PARTS & SERVICE NEWS

REF NO.	AT01223
DATE	Dec. 25, 2001

SUBJECT: REPAIR OF POWER TRAIN GUARD MOUNTING PORTION IN REAR FRAME ON WA1200-3

PURPOSE: To introduce modification procedures for the power train guard mounting plate on the rear frame of the WA1200-3 wheel loaders

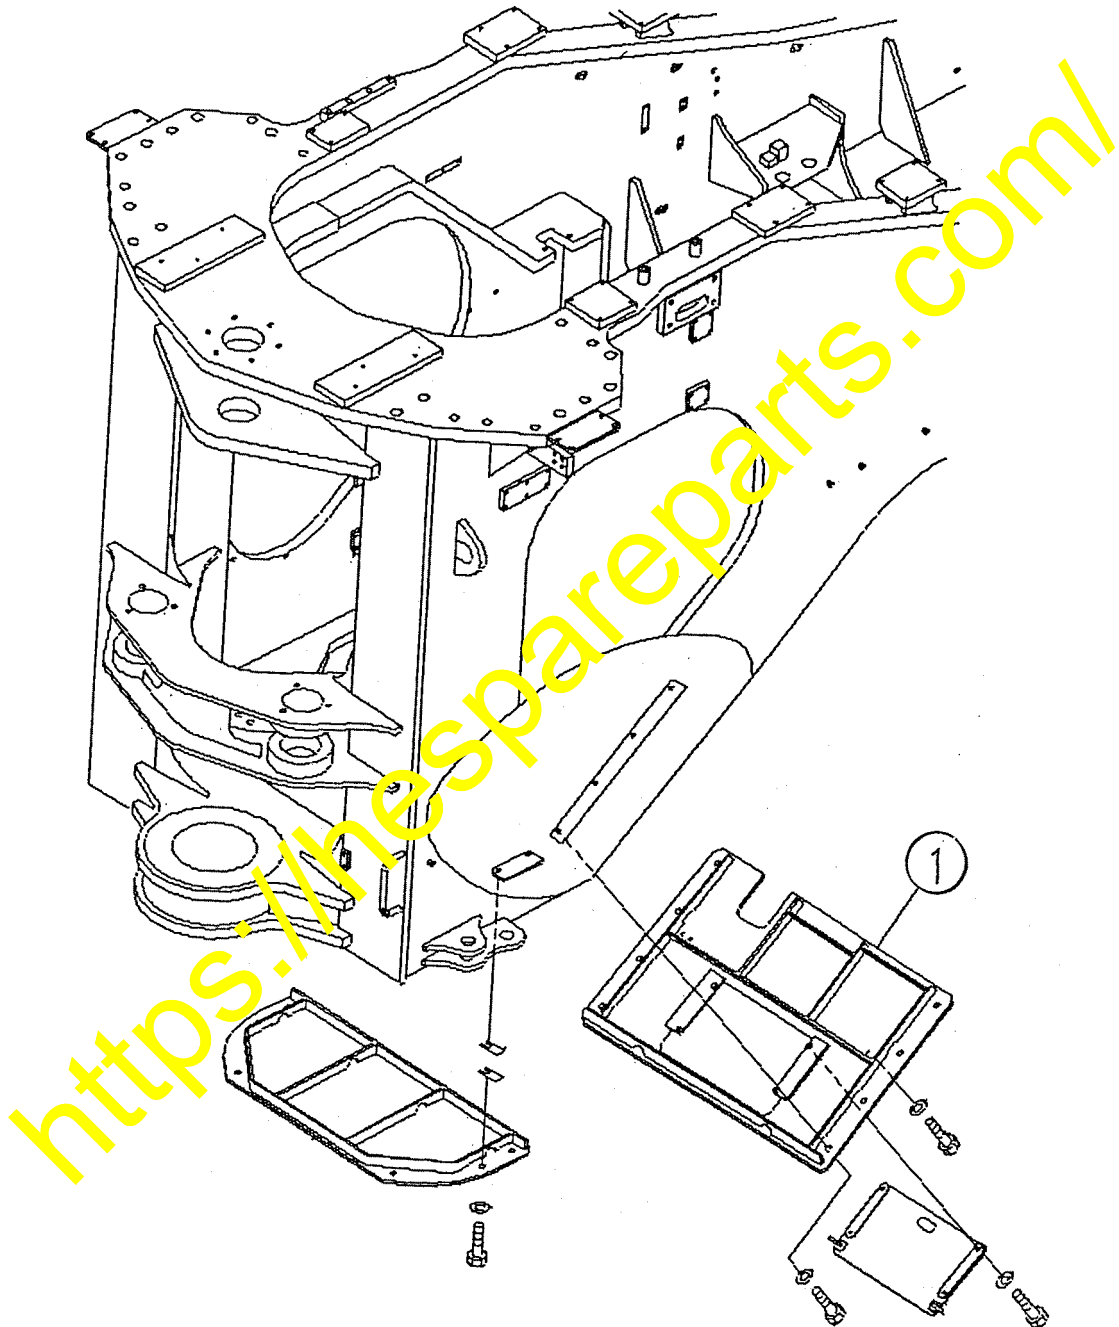
Cracks may occur starting from the welding end section of the power train guard mounting plate on the rear frame of the WA1200-3 wheel loaders extending toward the rear frame side.

It is possible to prevent occurrence of the above cracks by changing the shape of the mounting plate to ease the strain.

Therefore, implement the modification of the mounting plate following the procedures being outlined in this Service News.

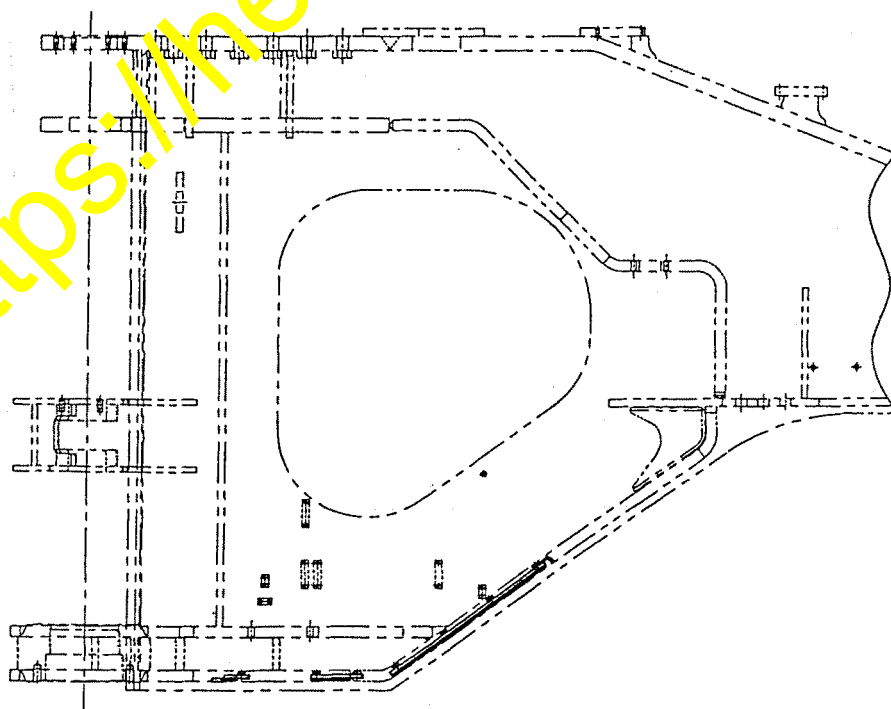
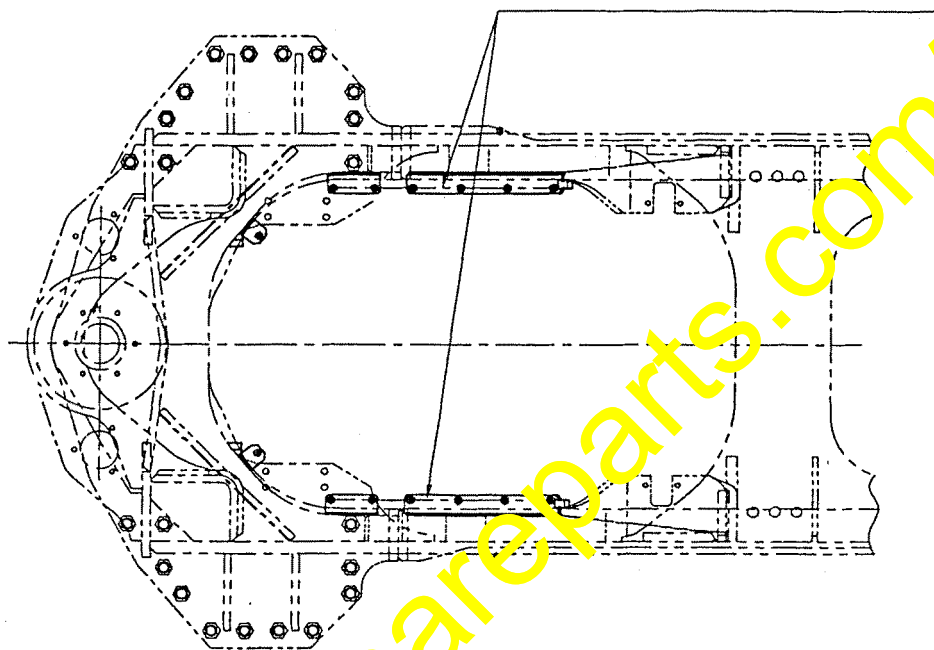
- (1) Before starting the additional work, remove the power train guard part ① as per the drawing below.

- (2) After that, carry out the additional work of the power train guard mounting plate as per the drawing below.

Change the shapes of these plates to the shape shown in the next page.

After finishing the additional work, paint the reworked section.

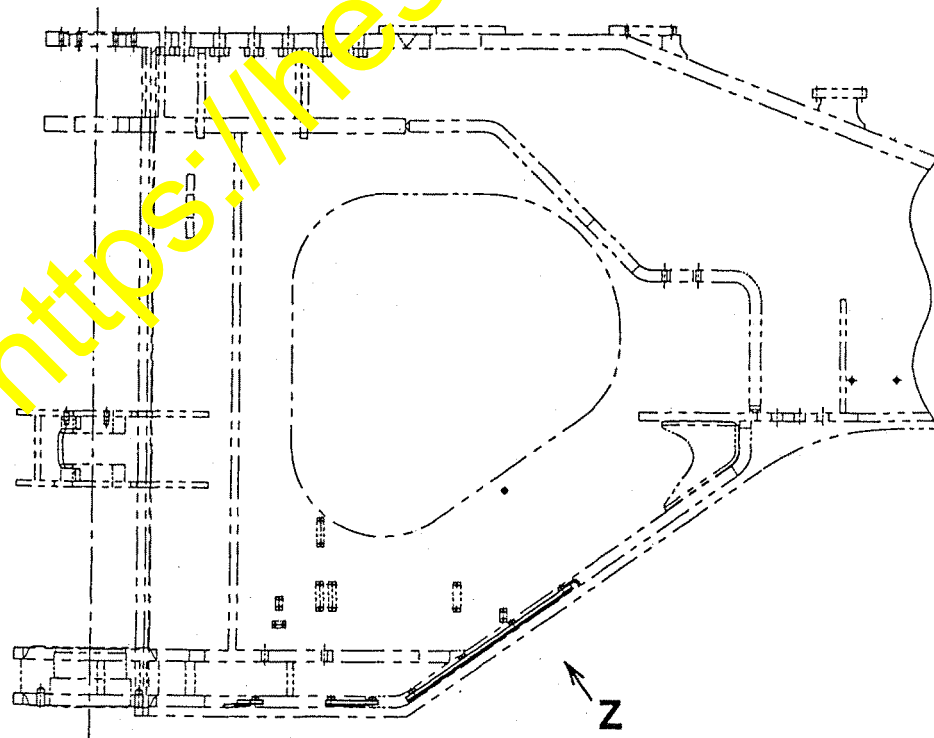
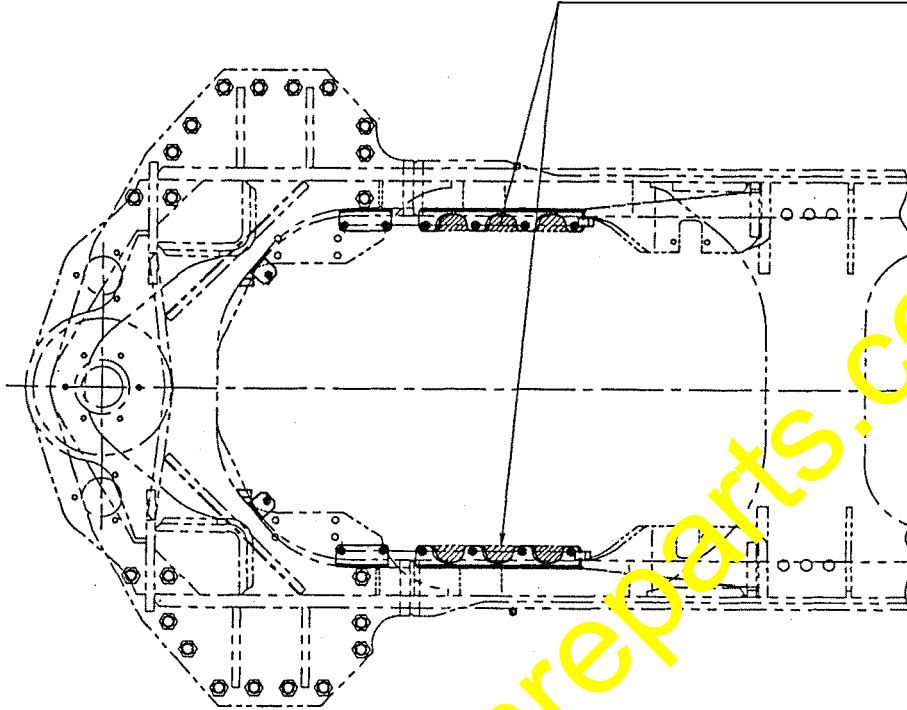
Remove the hatched sections of these plates.
Refer to the next page regarding the detailed dimensions.

Side plate, LH

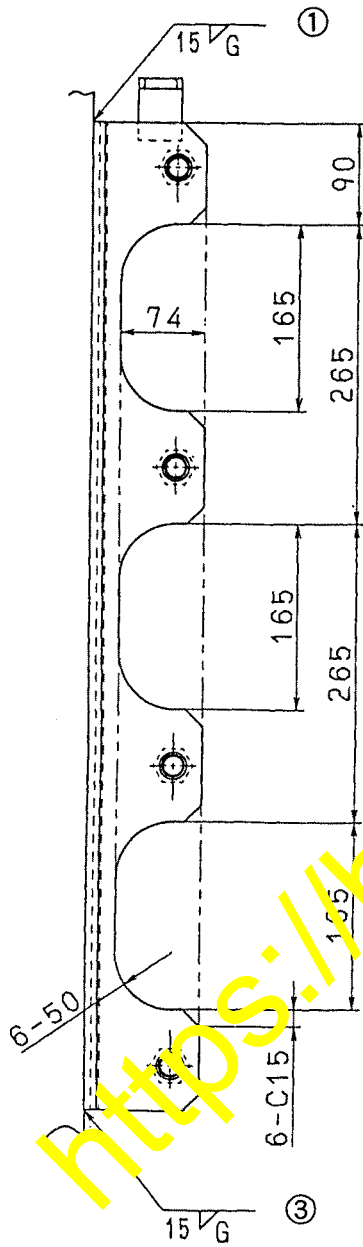
Detail dimensions for the additional work (View "Z")

Add the following welding as per the instructions given in the drawing below. (Welding as per ① thru ④)
